Planning Application 261243 at 8 Milton Road

Two Storey Side and Rear Extension, single storey rear extension plus garage conversion.

–Objection from ACER, The Whitegates Residents Association

Figure 4.37 (continued): Detailed guidance for assessing con

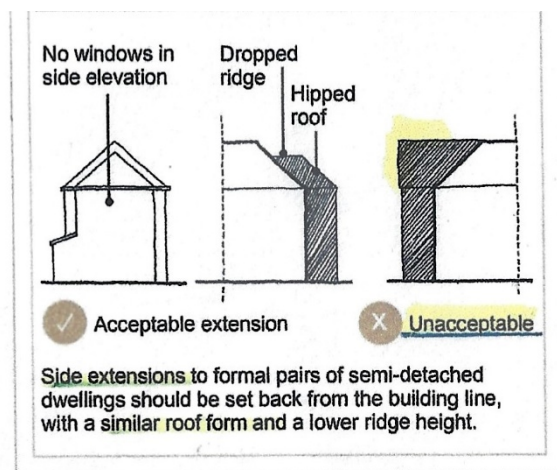
1. The unbroken two storey side and rear extension along the boundary with no.6 is both overbearing and dominant as well as being out of character and is therefore unacceptable.
2. The change from a sloping hip end roof to vertical gable end roof as proposed does not form part of the character of the area, which is for sloping hip-end roofs, as originally built. To introduce gable end roofs would not be in keeping, would not integrate with the street scene and would introduce unacceptable terracing.
3. There is clear guidance on retention of hip end roofs on side extensions within the Borough Design Guide on page 57, supported by a clear unambiguous diagram, shown below, which states that conversion from hip end to gable end is unacceptable
